1. All drawings 1:1, mm. Produce from the DXF files (layers CUT / SLIT; true arcs and ellipses). This PDF is the dimensioned reference.
2. Geometry is taken directly from the designer's vector PDF of 2026-10-14 - no re-tracing.
3. CUT (black) = outline, full cut. SLIT (red) = through cut, same rule height as CUT.
4. Slit lines that ran past the outline in the artwork were trimmed back to the outline (amount listed per sheet).
5. A 0.01 mm stray point inside pattern 03 was removed - it is not a cut.
6. Slits ending on the outline join the outline rule cleanly (T-joint), no gap, no overcut.
7. Suggested rule: 2pt centre-bevel, 23.8 mm height (or die maker standard) for leather 1.2-2.0 mm.
8. Optional: dia. 1.5 mm round punch at the closed end of each slit to stop tearing (confirm with designer).

OVERVIEW - REV 20261014 Reduced scale on this sheet only. Sheets 2-7 are 1:1.	SCALE **1 : 1**	DATE: 2026-10-14 SHEET: 1 / 7
Project: Leather no-sew interlocking patterns | REV 20261014 Source: 20261014_pattern-leather-cre.pdf (vector, exact geometry) Material: leather 1.2-2.0 mm | Process: steel-rule / clicker die	UNITS: mm TOL: +/-0.2 mm PAPER: A4 (print 100%)	DRAWN: Claude Code CHECKED: __

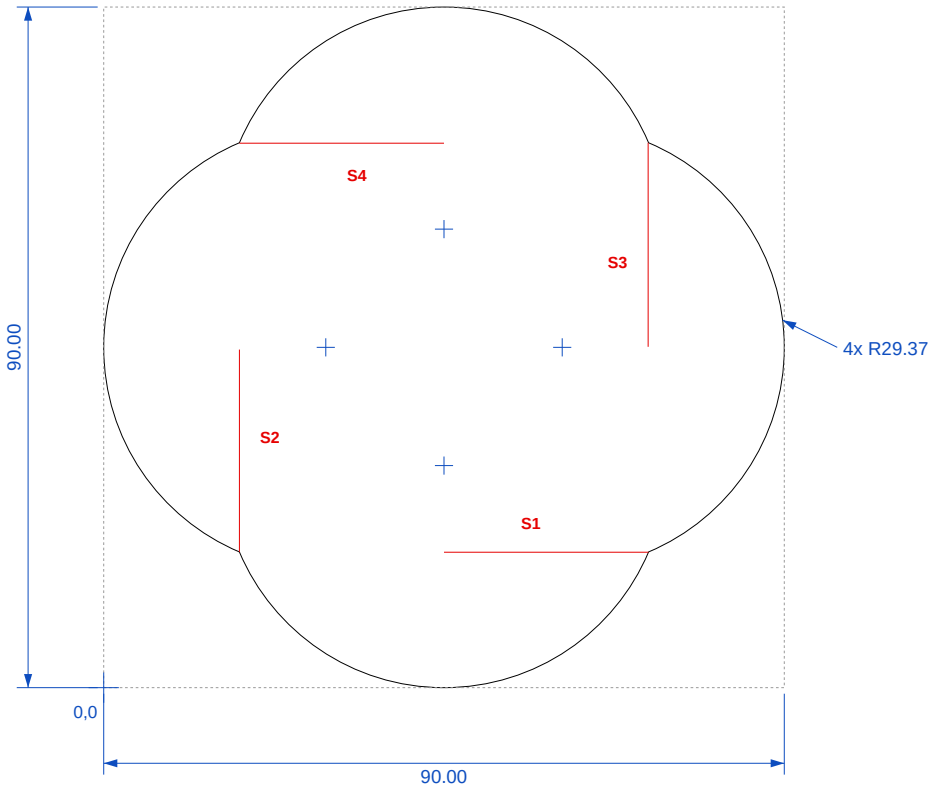
- Bear rotated 45 deg vs 20261013: ears now at top and right; slits now vertical (left) and horizontal (bottom).

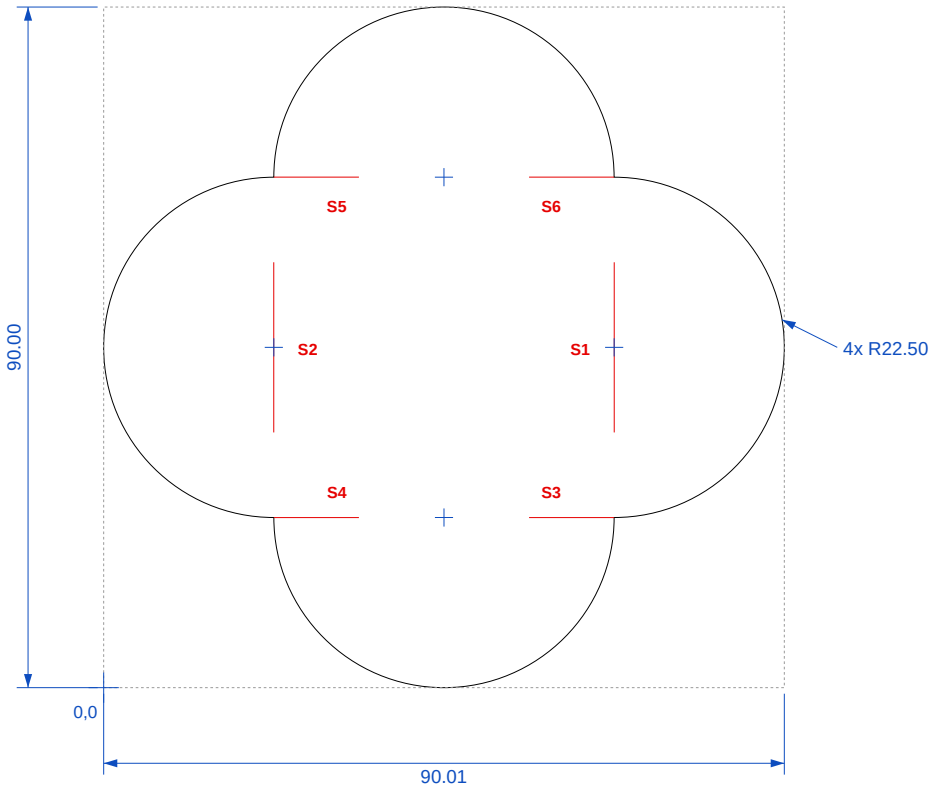
- Slots now 27.0 = exactly half of the 54.1 fold edge (were 29.25).
- Woven petal-box joint needs the two slots to overlap: keep >= 28.5 if that product is used.

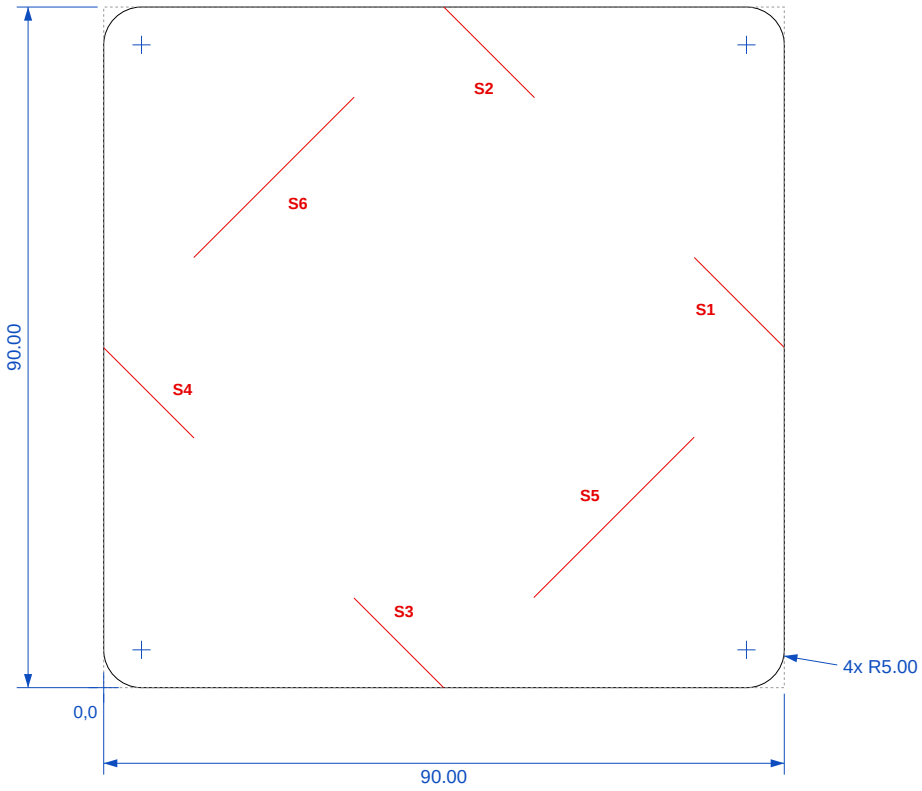
- Tab neck (45 - 2 x 11.25 = 22.5) equals receiving slit 22.5: zero clearance.
- Suggest slit 23.5 or slots 11.75 for ~1 mm clearance in 1.5 mm leather.

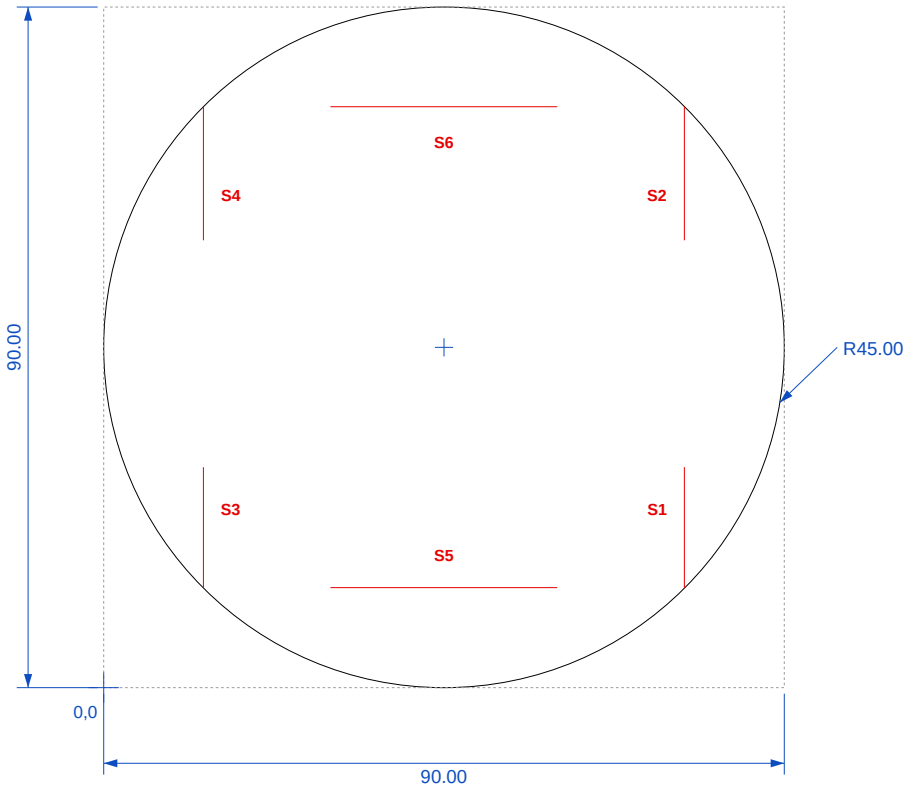
- Edge slots now 16.8-16.9 (were 15): tab neck ~29.9 vs slit 30.0 - about 0.1 mm clearance.

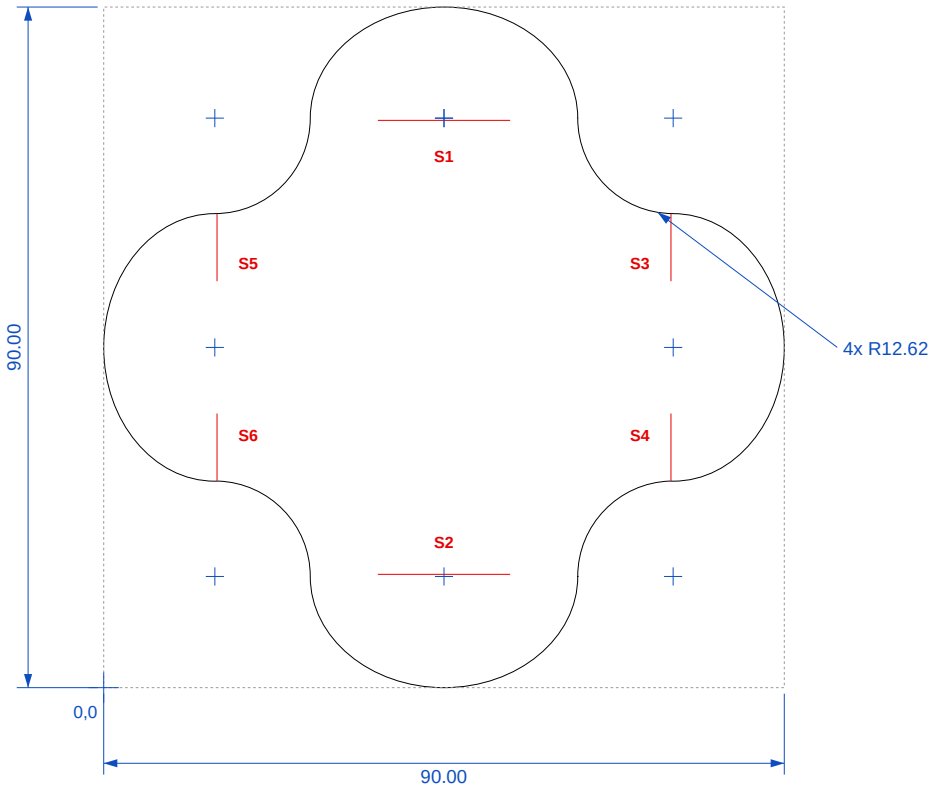
- Slots differ: top pair 17.7, bottom pair 16.0 - intended? Symmetric value for neck = slit is 16.82.
- Tab neck 30.0 equals slit 30.0: zero clearance. Suggest slots 17.3 each (~1 mm clearance).
